# HISTORIC AND DESIGN REVIEW COMMISSION

July 21, 2021

**HDRC CASE NO:** 2021-308  
**ADDRESS:** 601 DOLOROSA  
332 W COMMERCE  
**LEGAL DESCRIPTION:** NCB 254 BLK LOT S 113.78 FT OF BLK  
**ZONING:** D, H, HL, RIO-7B  
**CITY COUNCIL DIST.:** 1  
**DISTRICT:** Main/Military Plaza Historic District, RIO-7B, Central Business District  
**LANDMARK:** Continental Hotel, Arana Building, de la Garza House, O’Henry House  
**APPLICANT:** Irby Hightower/Alamo Architects  
**OWNER:** Mark Jensen/601 PAINFUL LP  
**TYPE OF WORK:** Rehabilitation of the Continental Hotel, Arana Building and de la Garza House and construction of a 15-story residential structure  
**APPLICATION RECEIVED:** June 18, 2021  
**60-DAY REVIEW:** Not applicable due to City Council Emergency Orders  
**CASE MANAGER:** Edward Hall

REMOVE NON-CONTRIBUTING ADDITION

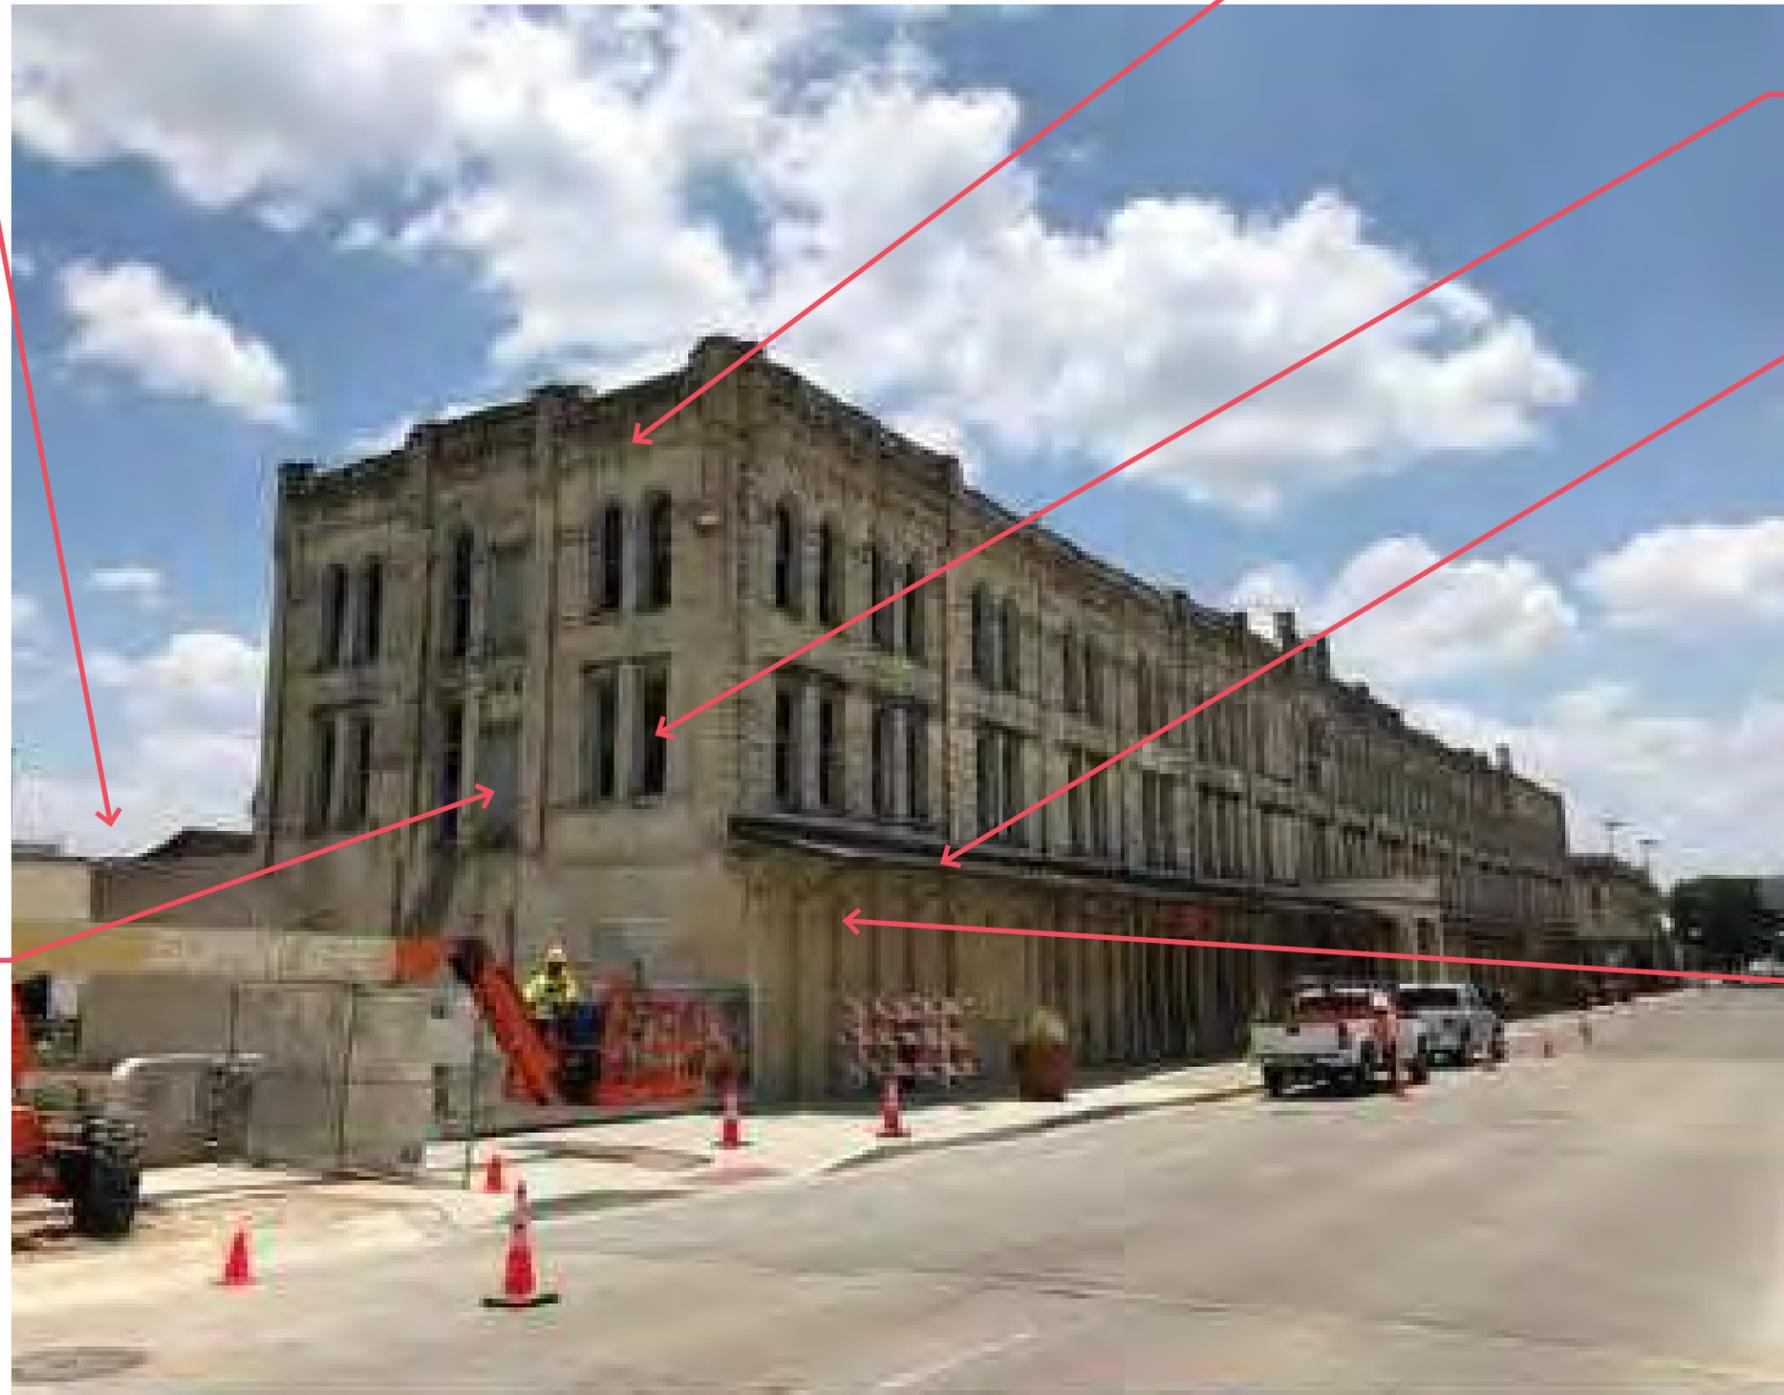
CLEAN AND RE-POINT BRICK

RESTORE EXISTING WINDOWS

REMOVE CANOPY AND INSTALL NEW CANOPY SIMILAR TO ORIGINAL

RESTORE WINDOWS. REMOVE TO INSTALL FIRE ESCAPE

REMOVE INFILLED MASONRY AND RESTORE ORIGINAL STOREFRONT OPENINGS. INSTALL STOREFRONT SIMILAR TO ORIGINAL

REMOVE FIRE ESCAPE  
AND RESTORE  
WINDOWS THAT WERE  
CHANGED TO DOORS

REPAIR EXISTING  
WINDOWS. REPLACE  
WITH SIMILAR  
WINDOWS WHERE  
MISSING

REMOVE OBSOLETE  
EQUIPMENT FROM  
REAR (SOUTH) WALL

MODIFY ROOF  
DRAINAGE AND  
REMOVE RAIN  
LEADER

**PRIMARY (SOUTH) ELEVATION WITH ORIGINAL STOREFRONTS**

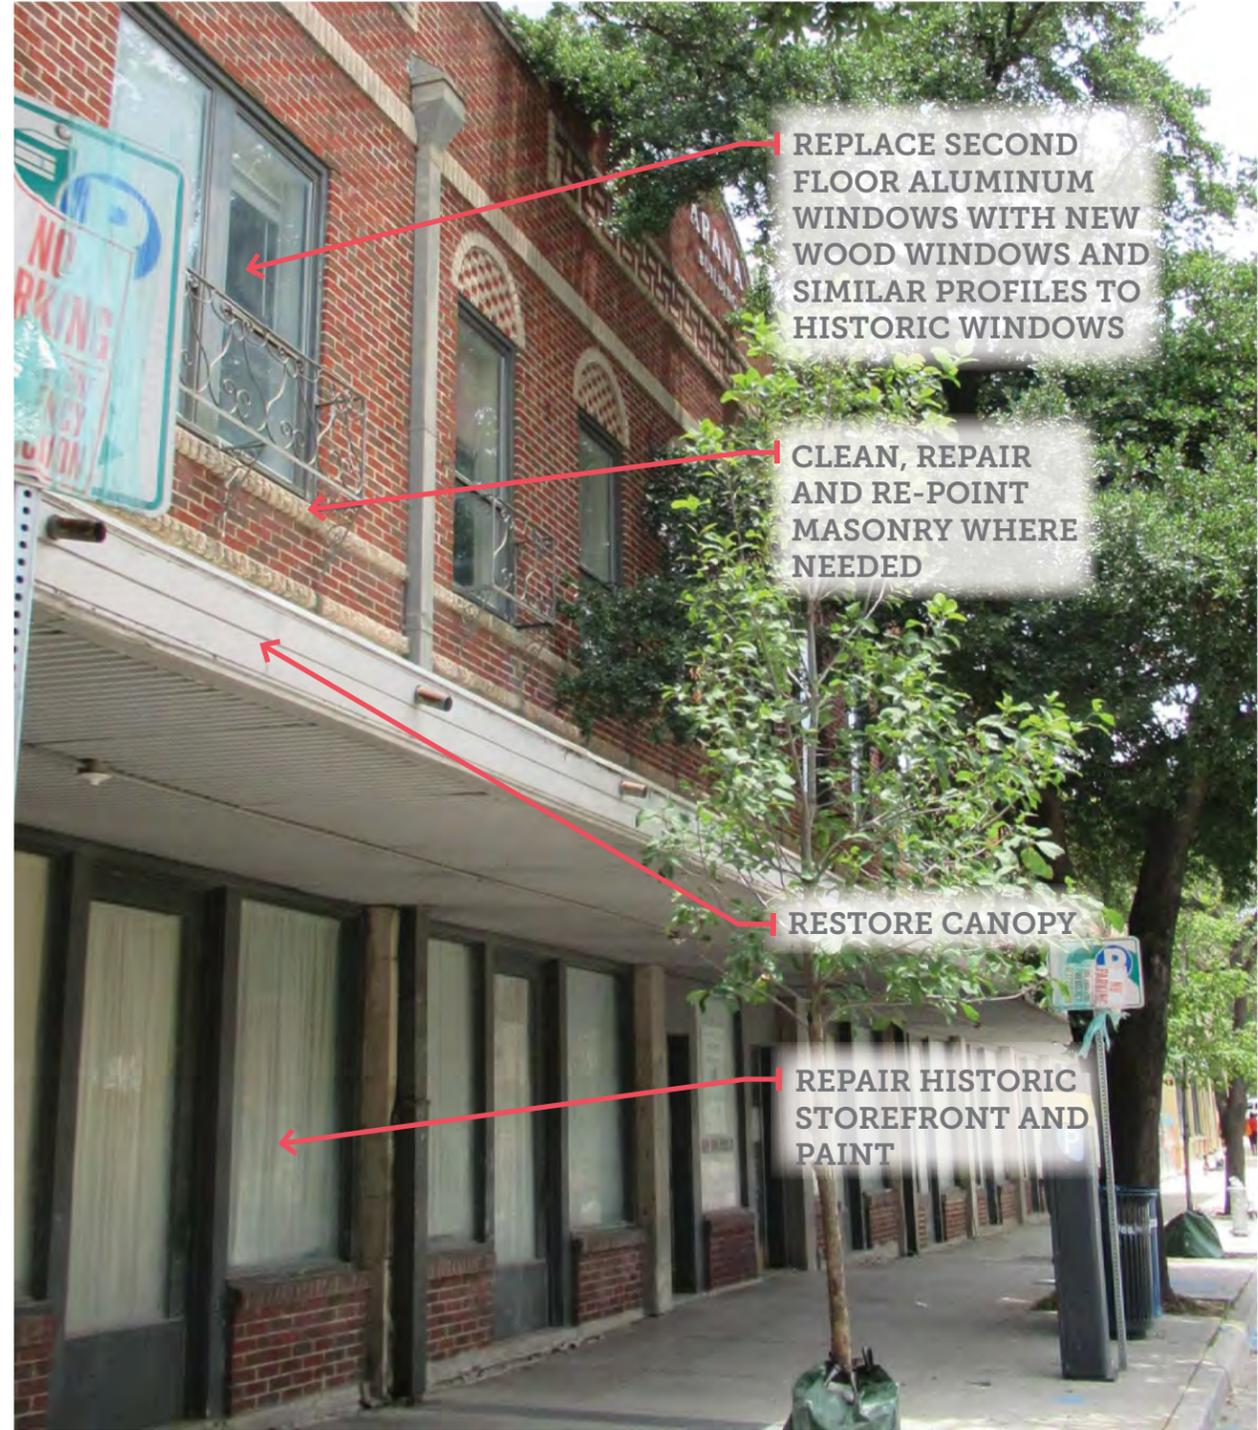
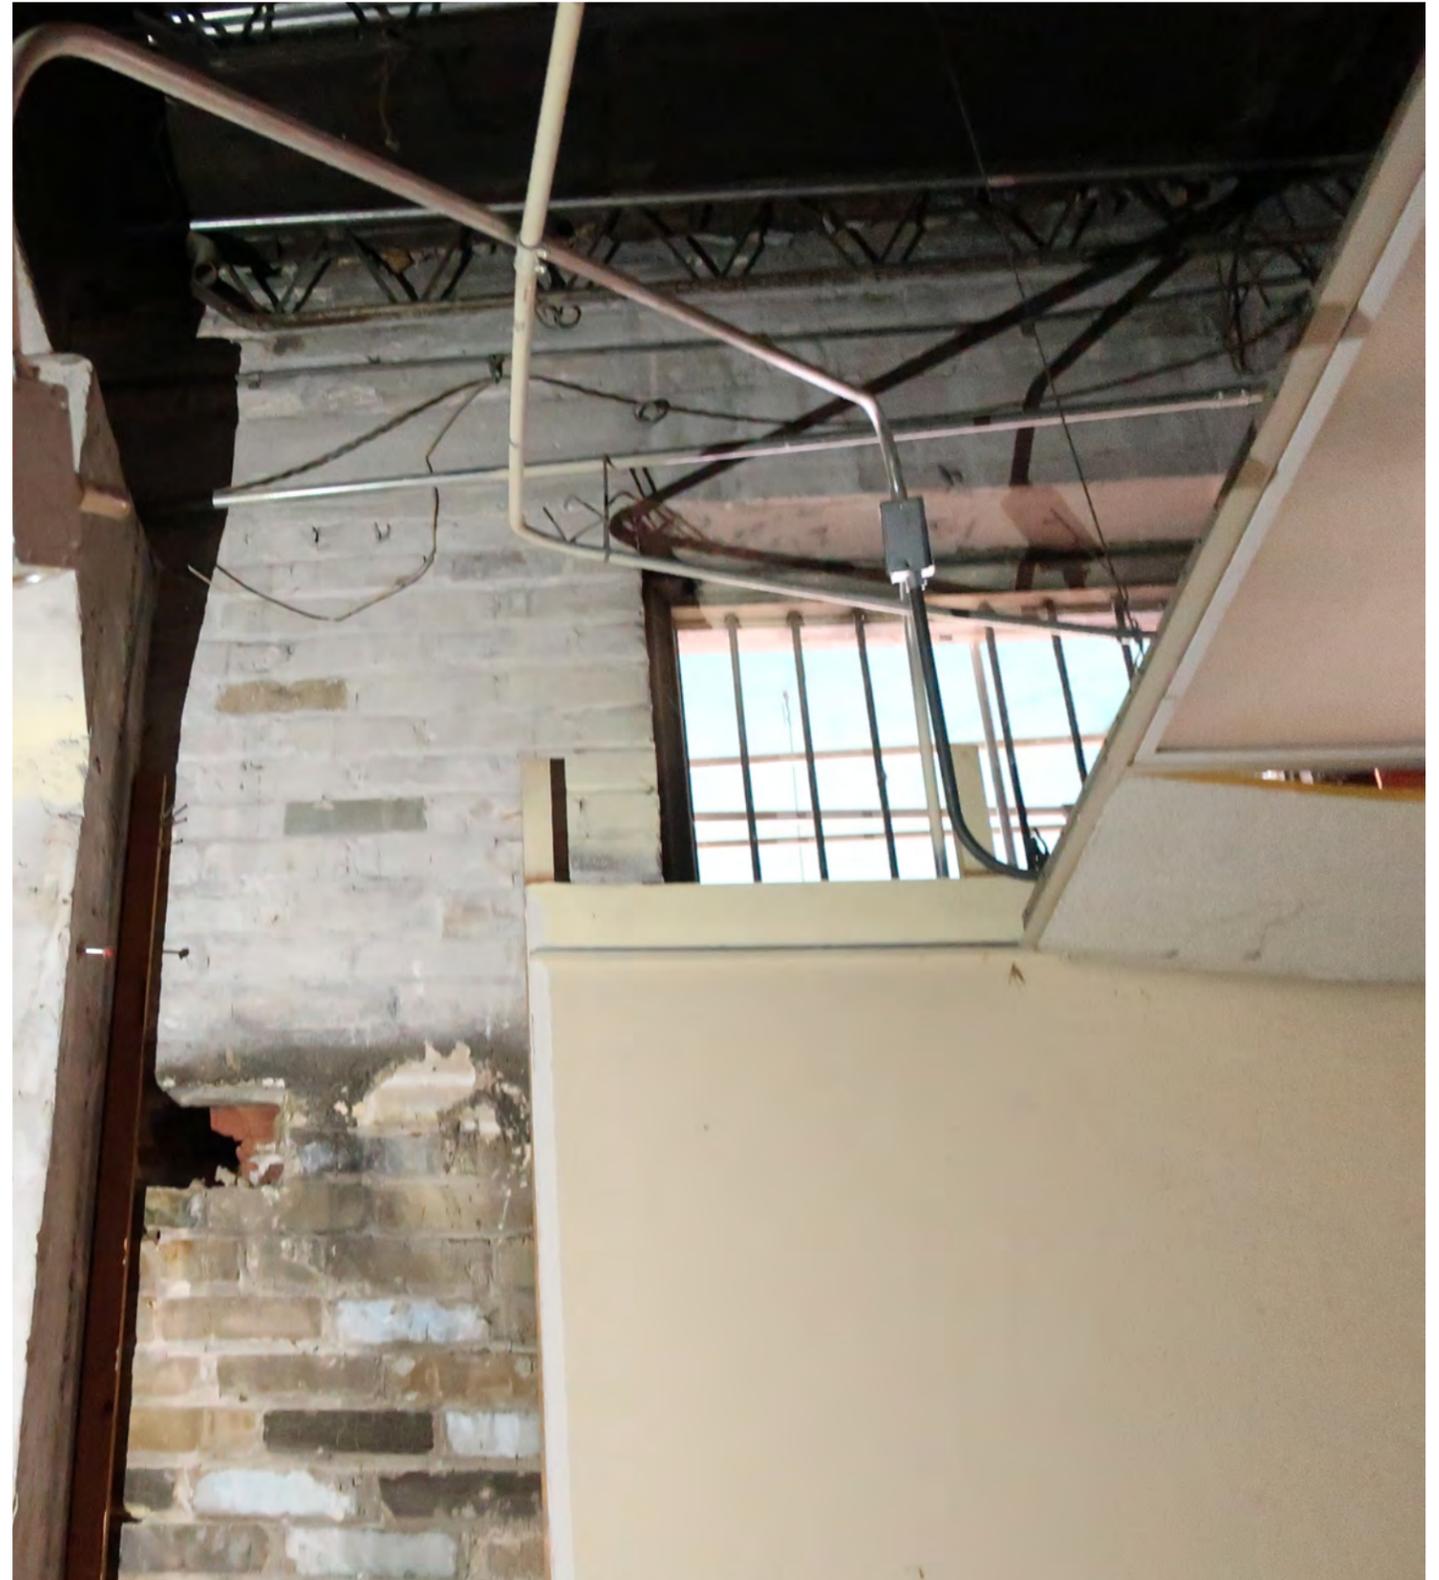
REPLACE SECOND FLOOR ALUMINUM WINDOWS WITH NEW WOOD WINDOWS AND SIMILAR PROFILES TO HISTORIC WINDOWS

CLEAN, REPAIR AND RE-POINT MASONRY WHERE NEEDED

RESTORE CANOPY

REPAIR HISTORIC STOREFRONT AND PAINT
